# MILLWARD STREET APARTMENTS

DEVELOPMENT PLAN RESUBMISSION

Re: Development Plan: 245 & 265 Millward Street

## P22-253 Dev. Plan Project Reviews

**A1.01**

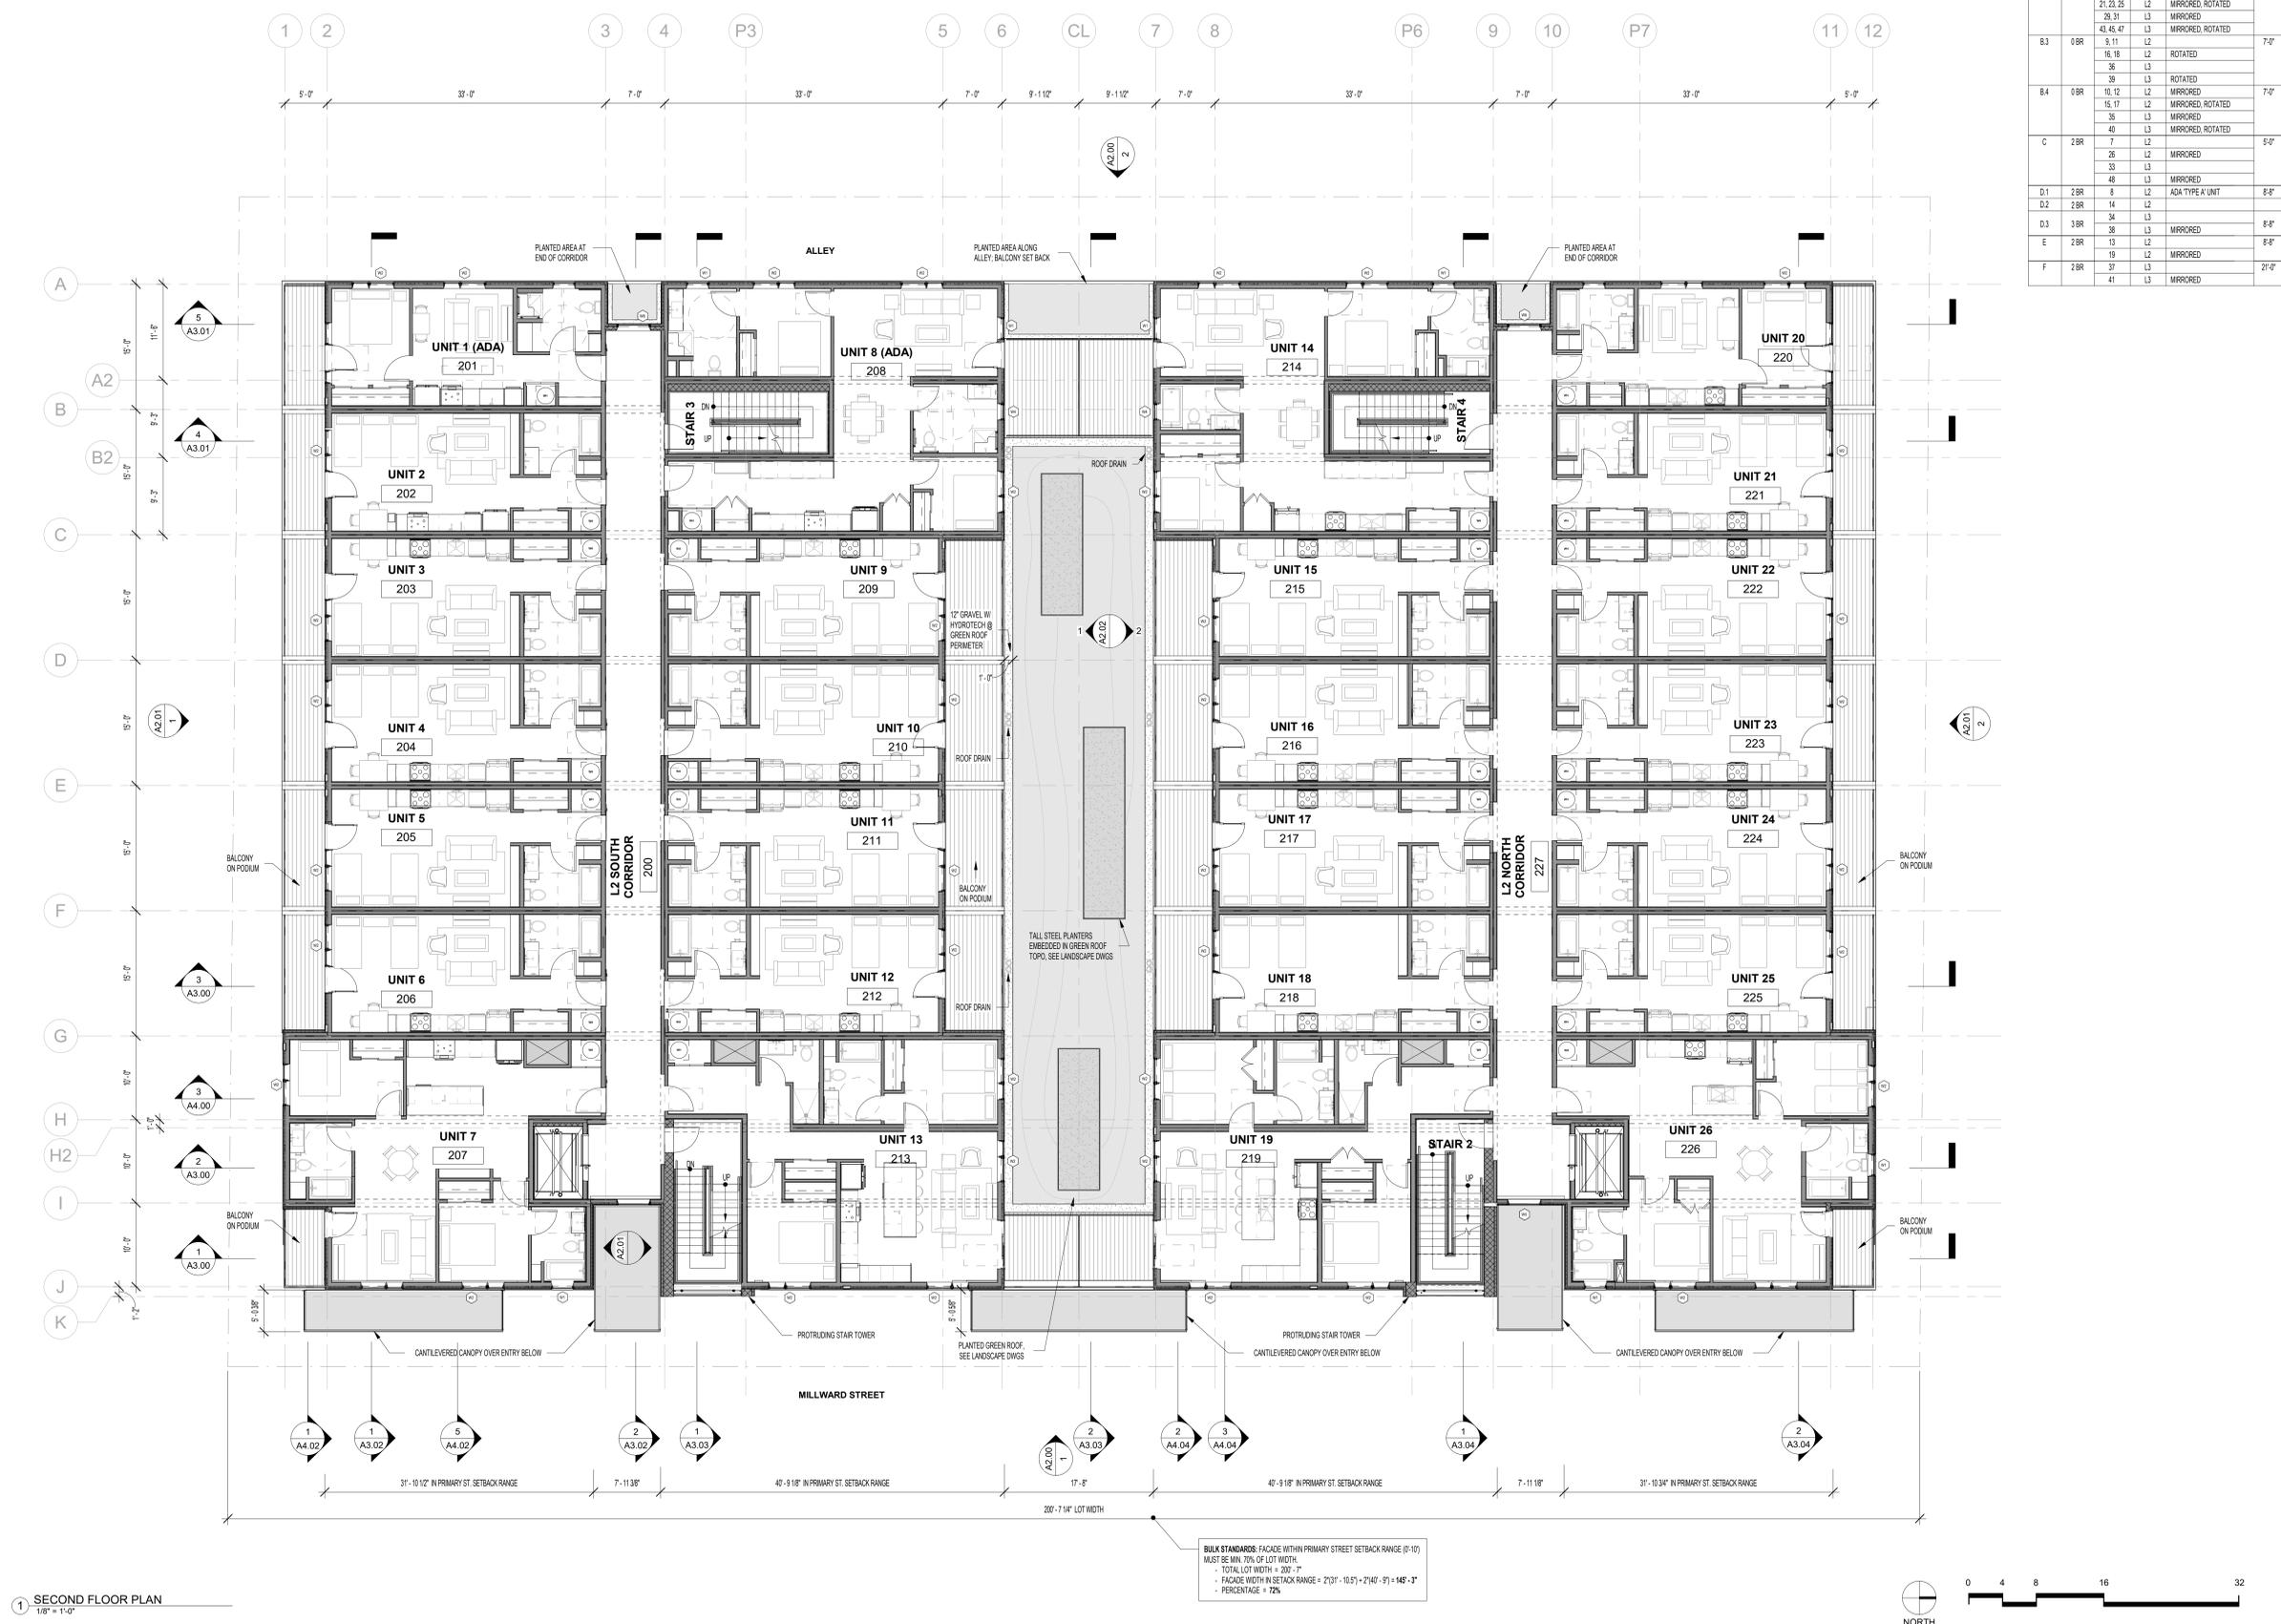
- Trash & recycling enclosure required. Revise plans to show location of trash enclosure or call out location if currently present. **Updated on A1.01, which shows two new walls to the west of the trash area (parallel to the alley) that will screen the trash and recycling from view. We believe that adding additional screening walls and/or doors/gates to access the trash enclosure will make it exceedingly difficult to roll away the dumpsters out for trash pickup. We have designed an ADA accessible path for approaching the dumpsters and believe that adding gates to screen them at the front will make it more difficult for a disabled person to take out the trash.**

- Planning Dept. highly suggests incorporating screening between the parking facility and side property lines. Consider fencing or landscaping options. **Planted areas have been extended along the north and south property lines, as shown in A1.01 and L0.3 and L4.0.**

- Revise plans to show dimension for distance between eastern property line and building. **Updated on A1.01.**
- Revise plans to show distance between existing “encroaching building” to the south and the proposed structure on 245 / 265 N. Millward. **Updated on A1.01.**

- Revise plans to show dimensions of on street parking spaces. **Updated on A1.01.**
- Revise plans to show dimensions of shorter compact parking spaces. **Updated on A1.01.**

- Please verify consistent dimensions for parking spaces in parking facility. It appears dimensions vary across different plans. **Updated on A1.01.**
- Revise ADA van space to be 8' wide with min 8' adjacent aisle. (11' + 5' shown). **Updated on A1.01.**

- Revise plans to account for pillars near parking spaces and show dimensions. Required width of parking spaces does not include structural pillars. Spaces with encroaching support pillars must be wide/long enough to capture the encroaching pillars plus the minimum required width or length of parking space. **Per latest feedback via email, we have updated the plans such that some columns encroach partway into the typical 9'-0" parking spaces, but not into any compact or ADA spaces.**

- Maximum of 8 compact parking spaces are allowed for parking plan with total of 54 onsite spaces. 9 are shown. **On A1.01, the column grids and parking layout were updated so that we now only have 6 compact spaces.**

- Update all plans (civil, landscape, architecture) to consistently show location of ADA and compact spaces. **Updated architecture, civil, and landscape sheets. See A1.01.**

- Applicant may apply parking facility dimensions provided in Resolution 09-25 for covered parking facilities. Applicant may choose to adjust plans to reflect Resolution 09-25 standards. **Updated on A1.01.**

- Revise plans to include 2' wheel stops at minimum for any parking space where vehicle overhang would impede amenities like walkways, storage locker doors, or bike rack (etc.). Planning Dept. suggests adding 2' wheel stops for all parking spaces. **Updated on A1.01.**

# A1.03

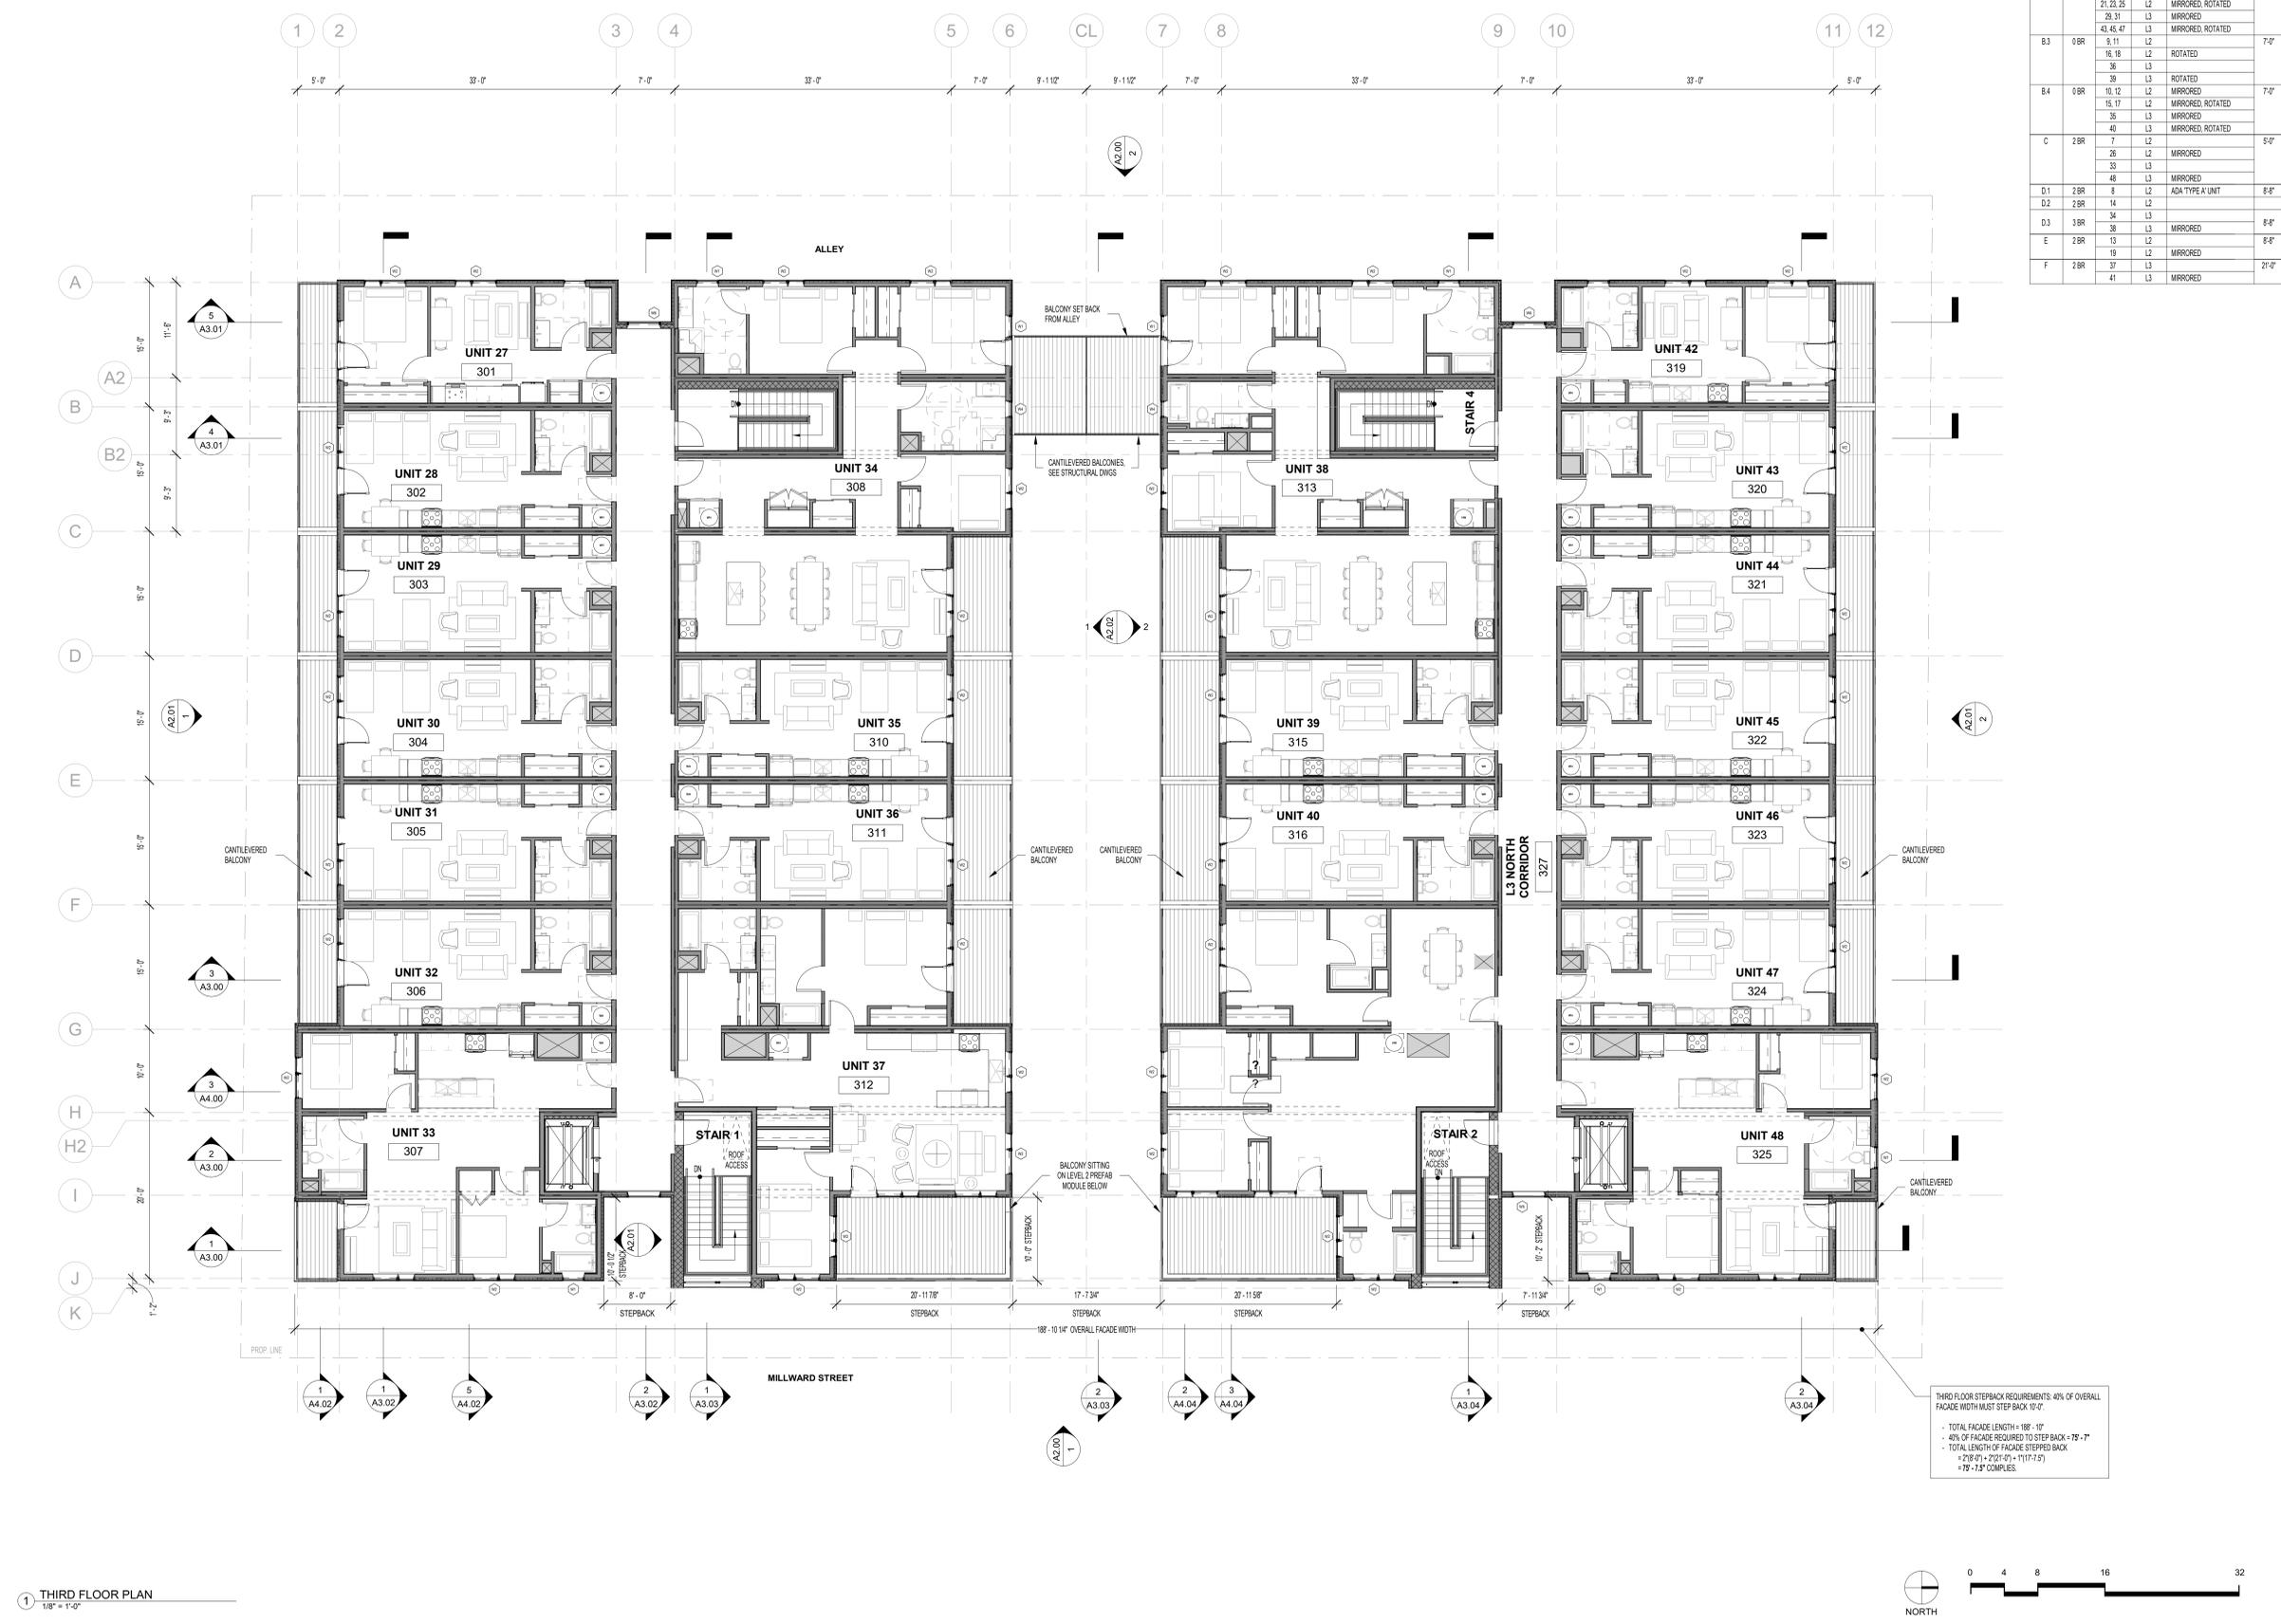
- Show dimensions on “first floor plan” and “second floor plan” (pgs 35-36 of packet submittal) for calculations that min 70% of lot width has ground and 2nd story building façade in primary street setback range (0'-10' as measured from back of pedestrian frontage). Similar to how stepback is shown on page 37

third floor plan. Calculated by dividing the façade width located in the specified setback range by the width of the lot. **Updated on A1.01, A1.02, and A1.03.**

**A2.00**

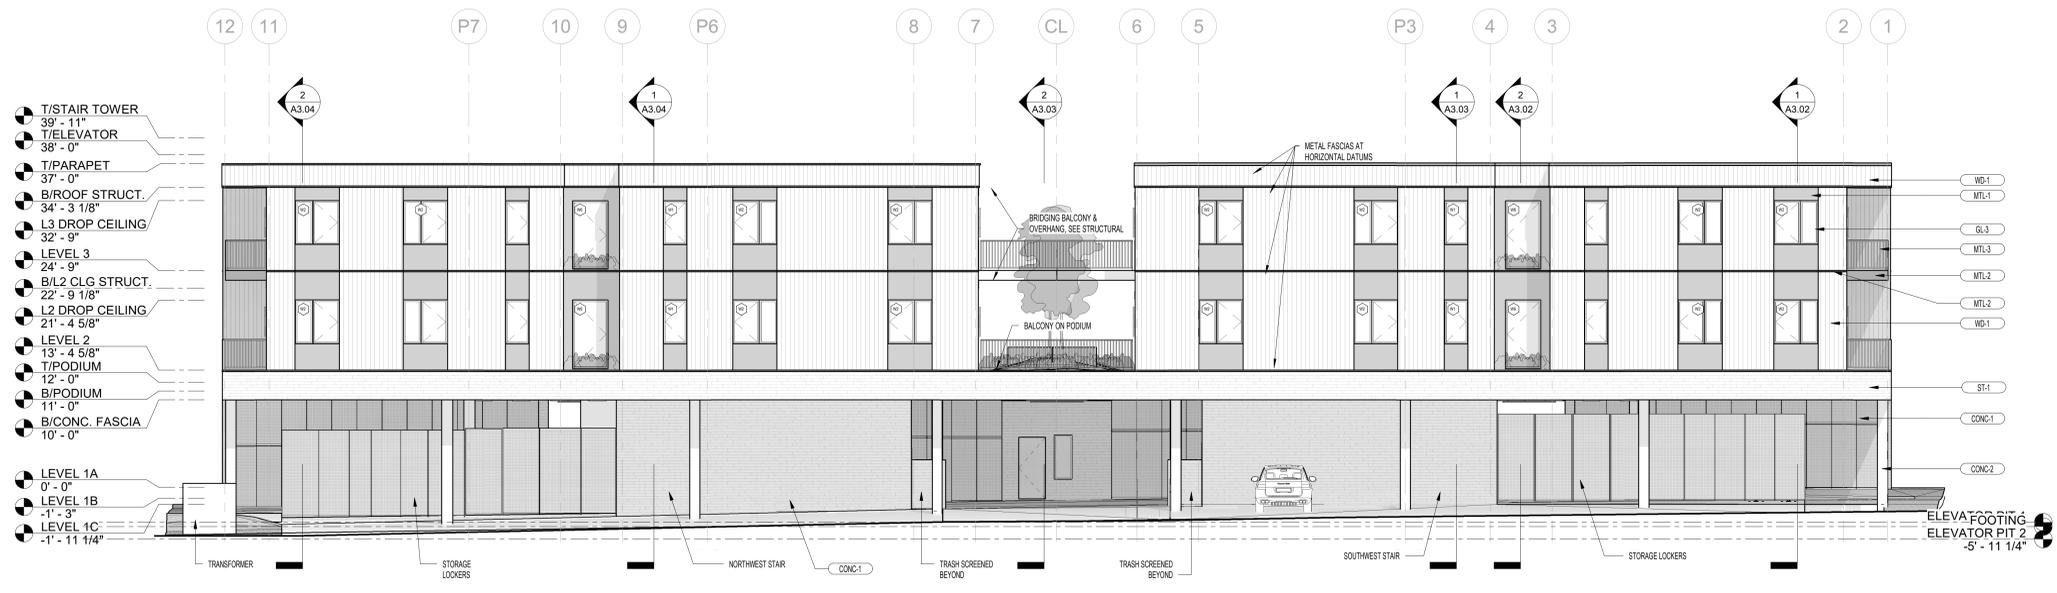
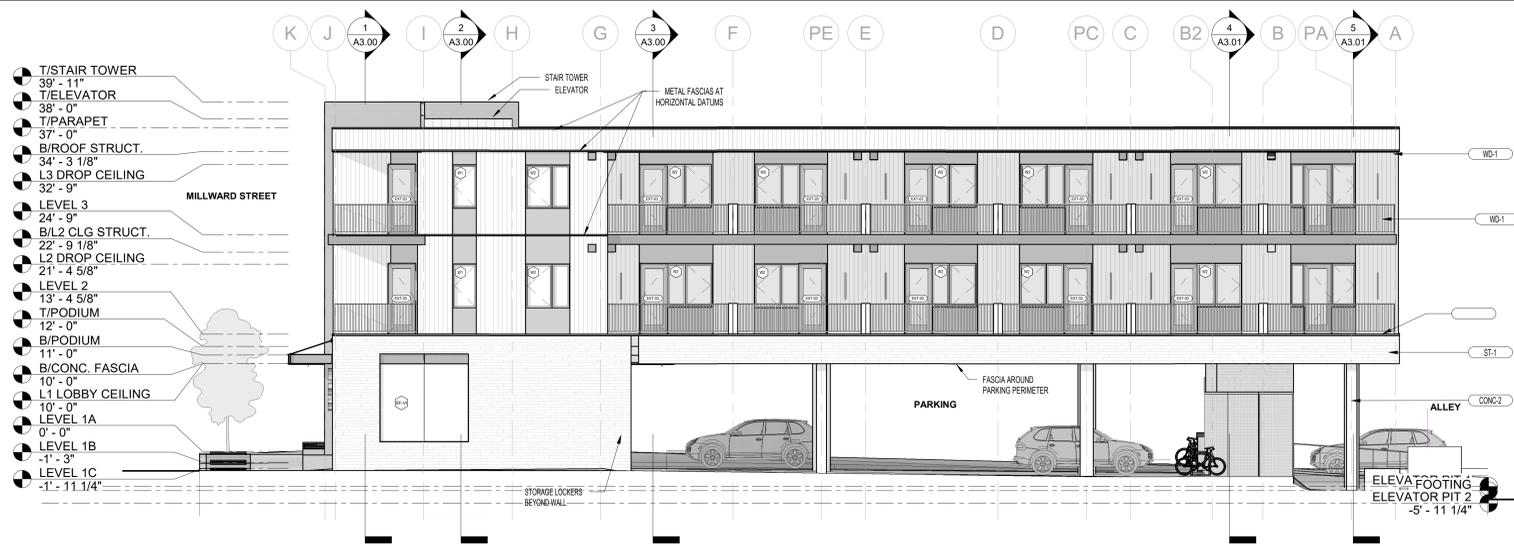
- Building Frontage (Shopfront vs. Office Frontage). Revise LDR compliance table to select only one (it is not tied to use) and to list subcategory compliance, specifically story height, transparency, blank walls, ped access. Revise elevations and floor plans to call out subcategory compliance (for frontage type) such as transparency requirements. May be similar to applicant providing stepback calcs on pg 37 of submittal packet. **Updated in LDR Compliance table and in architectural plans and elevations. See A2.00 for façade calculations.**
